LAKE PONTCHARTRAIN, LA. AND VICINITY
LAKE PONTCHARTRAIN BARRIER PLAN

DESIGN MEMORANDUM NO. 2 - GENERAL DESIGN
SUPPLEMENT NO. 3

CHEF MENTEUR PASS COMPLEX

LMVED-TD (NOD 17 Jun 69) 3d Ind
SUBJECT: Lake Pontchartrain, Louisiana and Vicinity, Lake Pontchartrain
Barrier Plan, General Design Memorandum No. 2, Supplement No. 3,
Chef Menteur Pass Complex

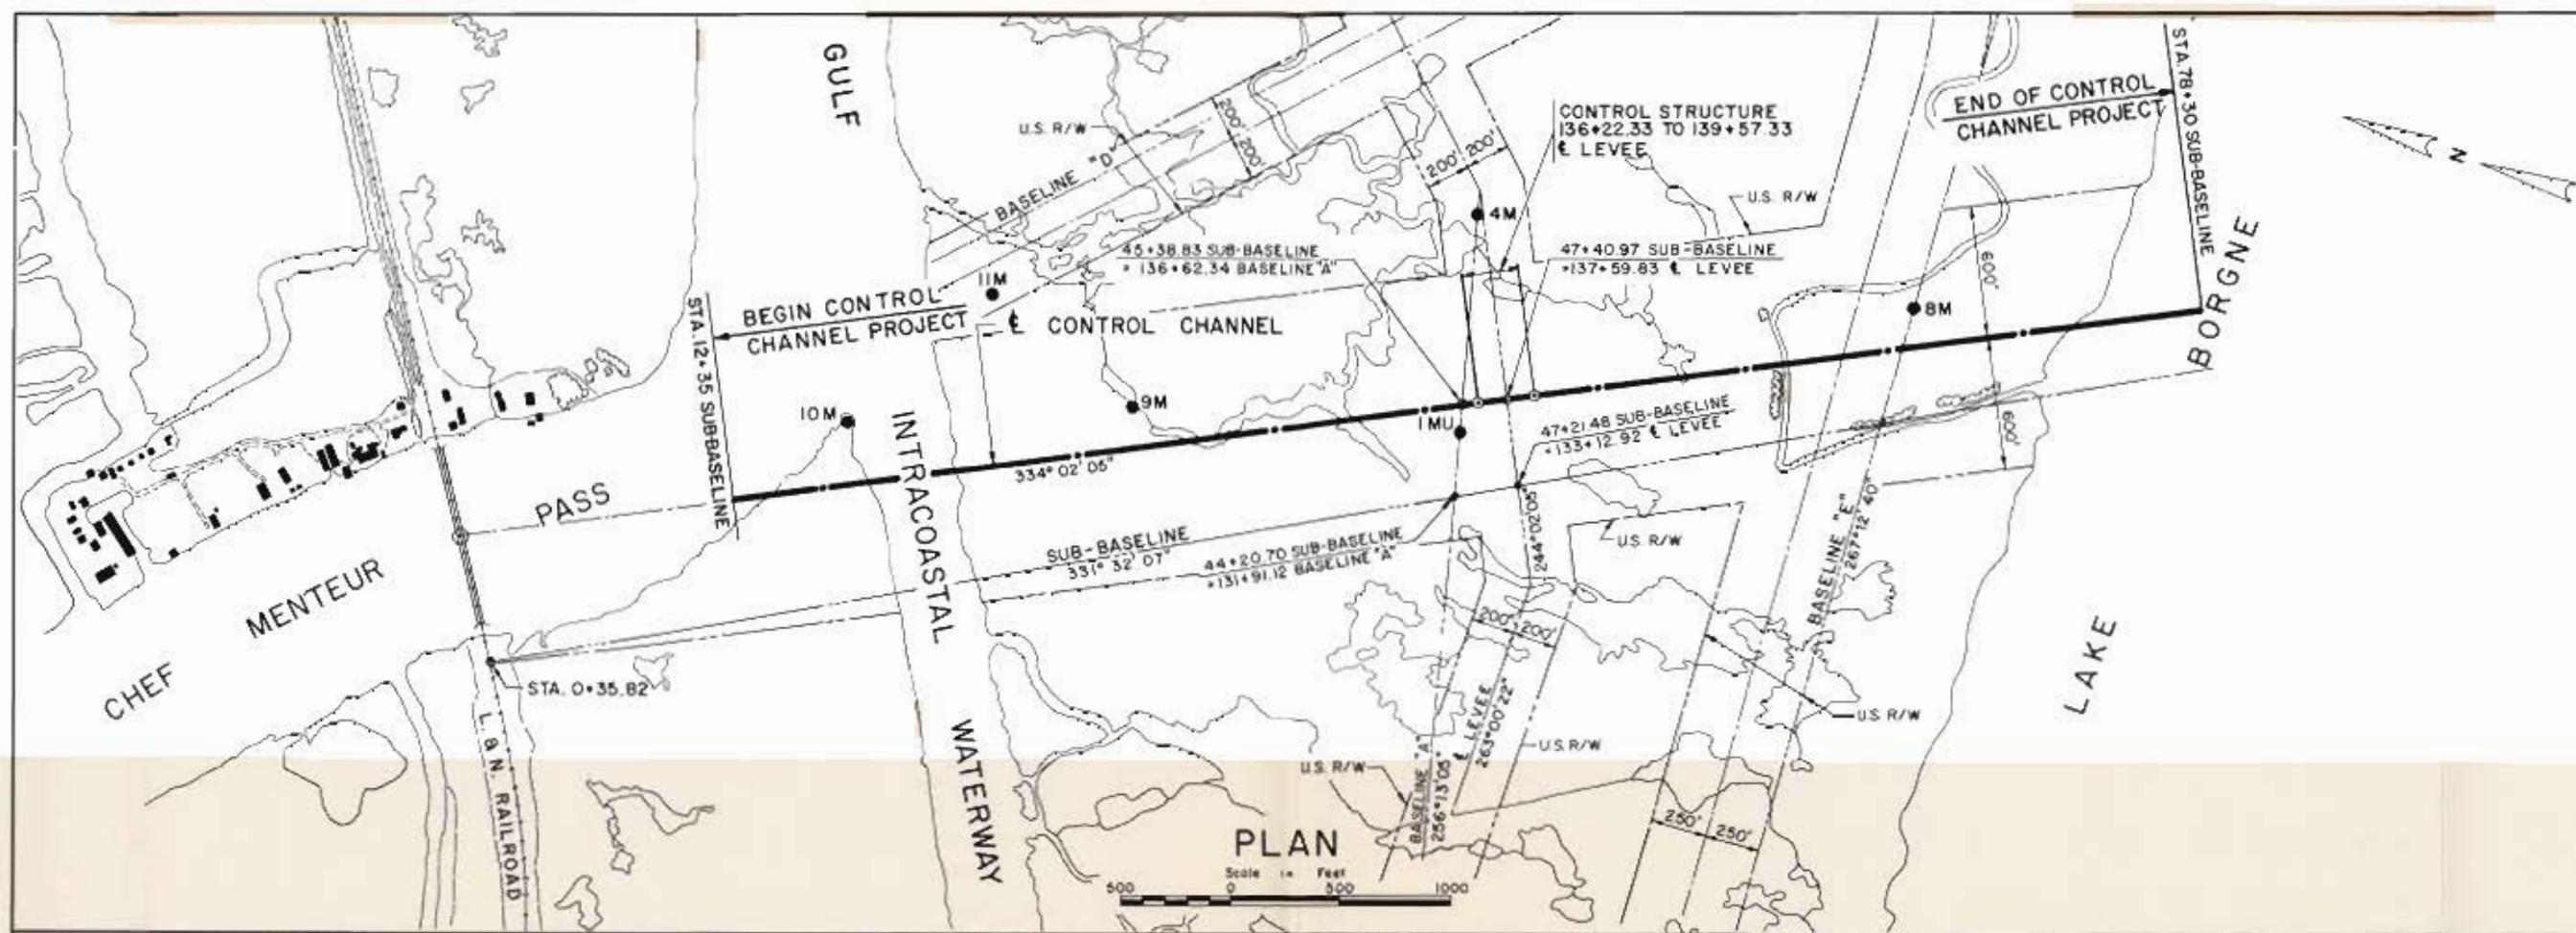
27. Plate 7. Borings 10-MU and 11-MU should be indicated in plan on this drawing.

TYPICAL SECTION - RELOCATED G.I.W.W., NAVIGATION CHANNEL, CAST DIKES AND SPOIL AREA

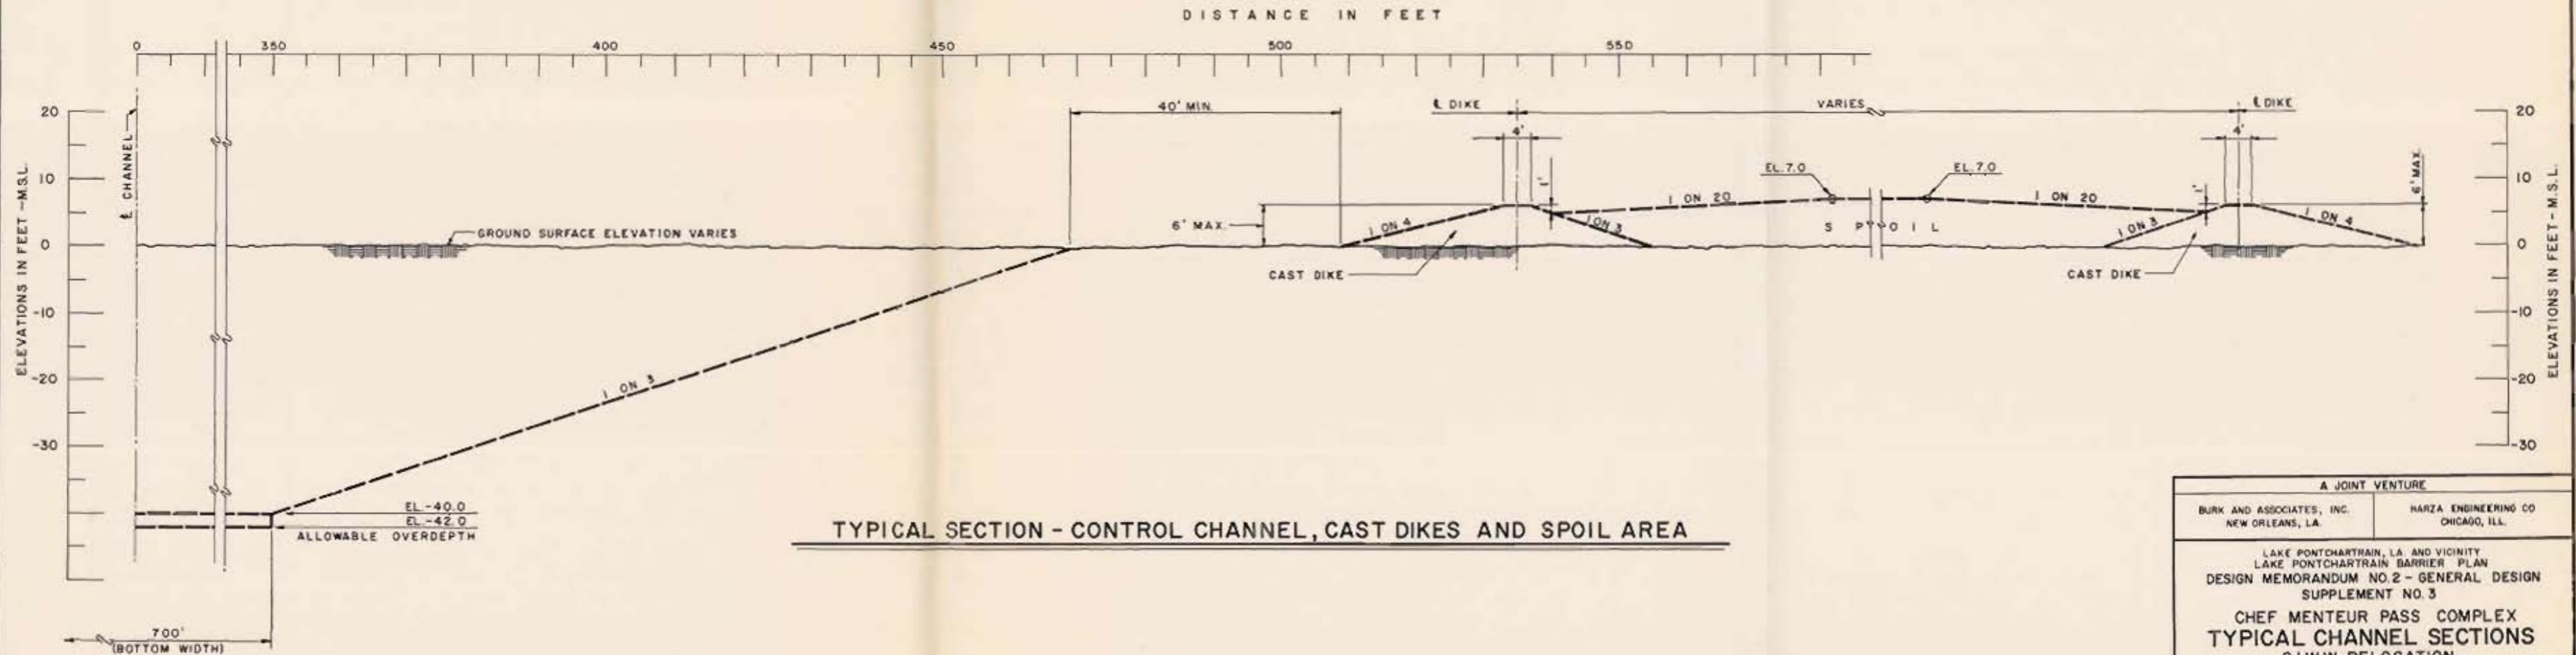
35. Plates 27 and 31. The 40-ft minimum berm distance shown for the typical section of relocated GIWW, navigation channel, cast dikes and spoil areas on Plate 27 does not agree with the berm distance shown on the GIWW relocation stability analysis for sta 660+00 to 770+00 on Plate 31. The contract drawings for the new GIWW should be prepared so as to provide the berm distances required by the slope stability analyses.
